STATE OF CALIFORNIA
REGIONAL WATER QUALITY CONTROL BOARD
SAN FRANCISCO BAY REGION

STAFF SUMMARY REPORT (Michael Rochette)
MEETING DATE: May 9, 2007

SUBJECT: East Bay Municipal Utility District (EBMUD), Bayside Groundwater Project, San Lorenzo, Alameda County – Adoption of New Waste Discharge Requirements

**REVISED TENTATIVE ORDER
WASTE DISCHARGE REQUIREMENTS**

Figure 1: Monitoring Well Network

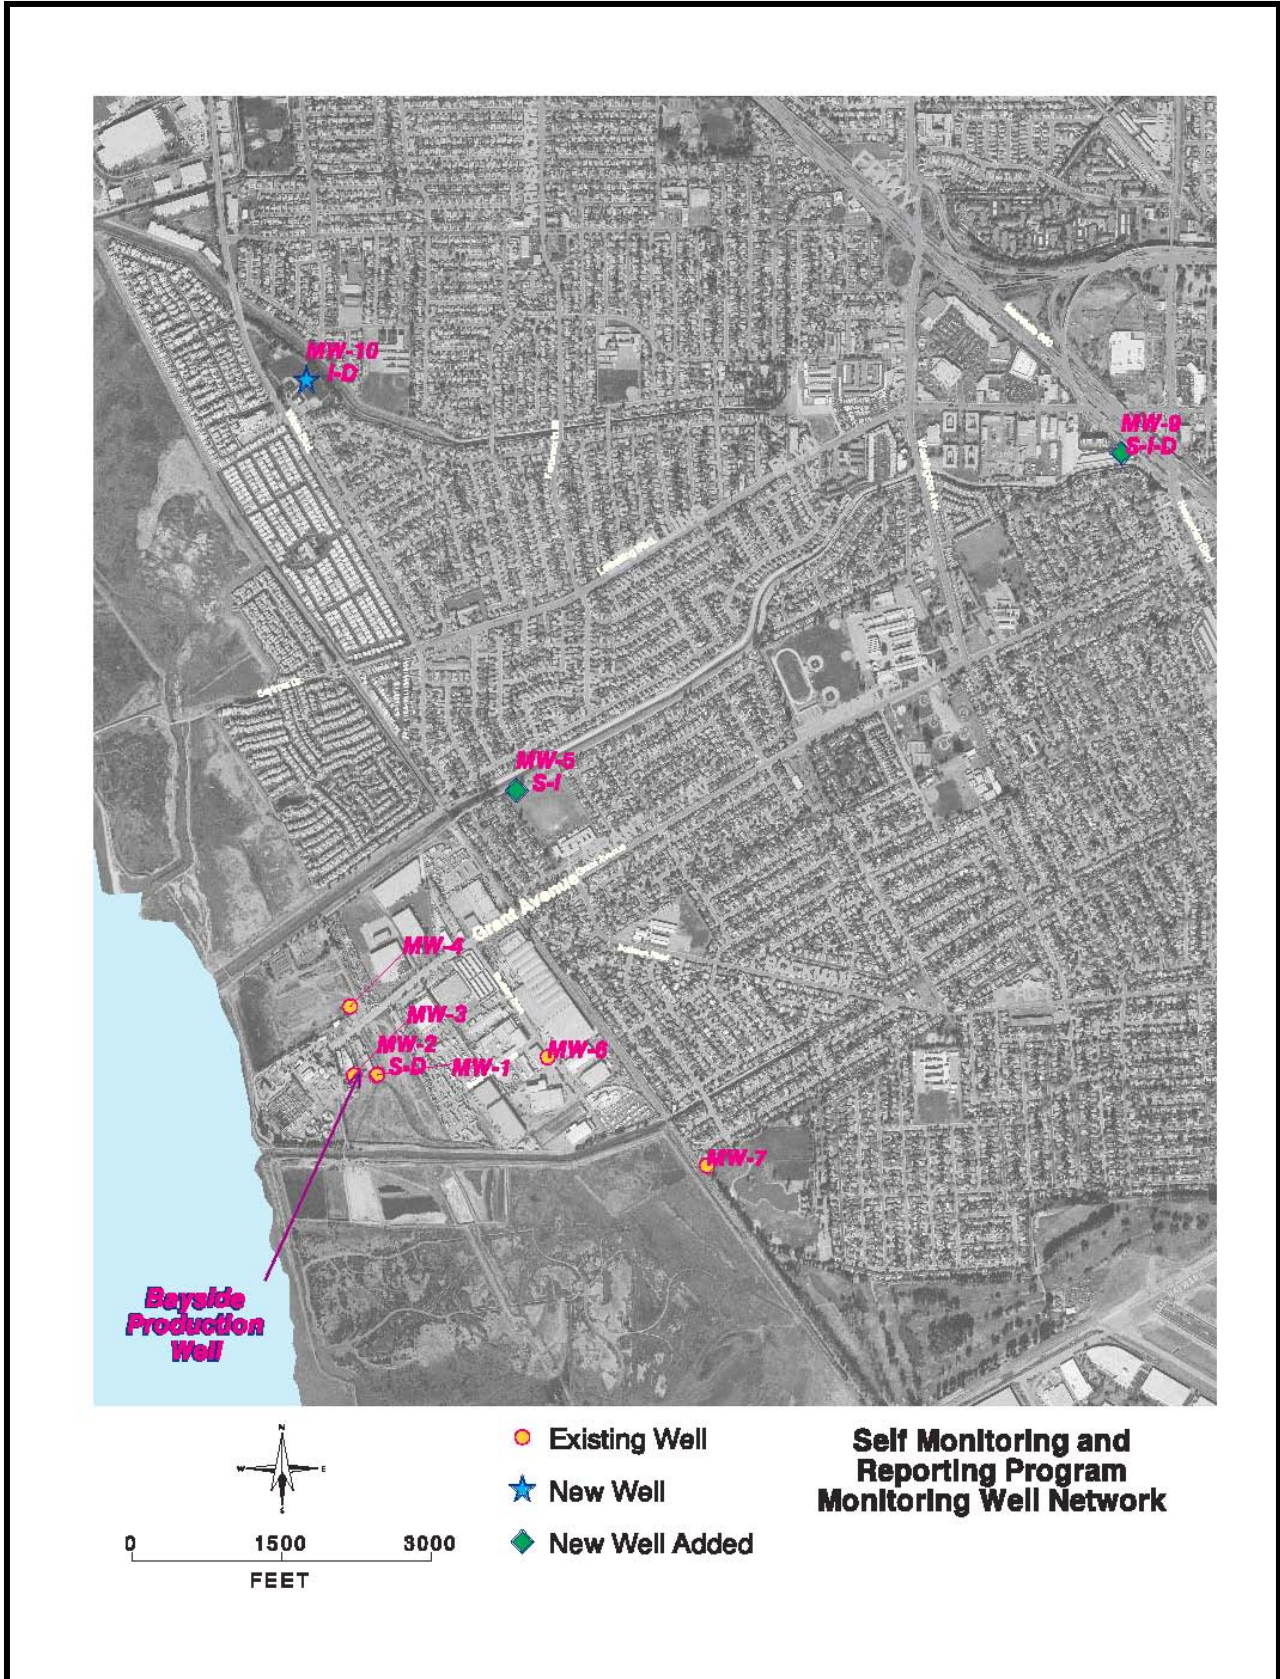
We request the language in the Order be modified to require monitoring of the these omitted monitoring wells (in addition to those already included in the Table 1 of Attachment A in the Self Monitoring Program), or an alternative network of wells that provide similar vertical and lateral coverage on a basin-wide scale, and that the monitoring of the network adhere to a schedule as follows:

Startup Period Monitoring, Including Higher Frequency Monitoring to Capture Short-Term Response to Startup. Table 1 of Attachment A of the Self Monitoring Program indicates EBMUD's intent to provide high frequency monitoring (readings every 30 minutes to 1 hour) of certain wells during the 1-year startup period for the Project. We applaud this, as we see it presenting an opportunity to gage short term hydraulic responses of the aquifer system to introduction of Bayside-related stresses, similar to what was provided through the 2002 pump test of Hayward emergency supply wells. In order to capture the response near and within the transition zone, we request that certain other wells listed in the above noted table of omitted wells be included for similar high frequency monitoring during the startup period, particularly those wells located in Hayward and/or the transition zone. We request and recommend that high frequency monitoring of such wells occur for at least one week prior to each change in mode of operations (including initial startup of operations) plus one week following the change, to ensure adequate data to compare conditions just before a change in mode of operation to conditions following the change.

This information will be acquired by EBMUD as part of the Bayside Project Phase 1 Monitoring Well Network (BPMWN) that EBMUD committed to in its EIR. These data are not relevant for the Phase 1 project being permitted, as no impacts to seawater intrusion are anticipated if operations are consistent with the project as modeled. They are important if EBMUD decides to pursue Phase 2 of the project and Staff would expect these data to be submitted with a new ROWD. Staff revised the discussion about modeling of groundwater levels in Finding 12. Staff also included a reference to the Bayside Project Phase 1 Monitoring Well Network into Finding

12 and added a reference to Provision 4 to include the BPMWN data in the annual monitoring report.

ACWD and the City of Hayward are identified in the revised Tentative Order to receive copies of all correspondence, technical reports, and other documents pertaining to compliance with the Order. Staff also modified Provision 4 to include reporting of the BPMWN groundwater levels.
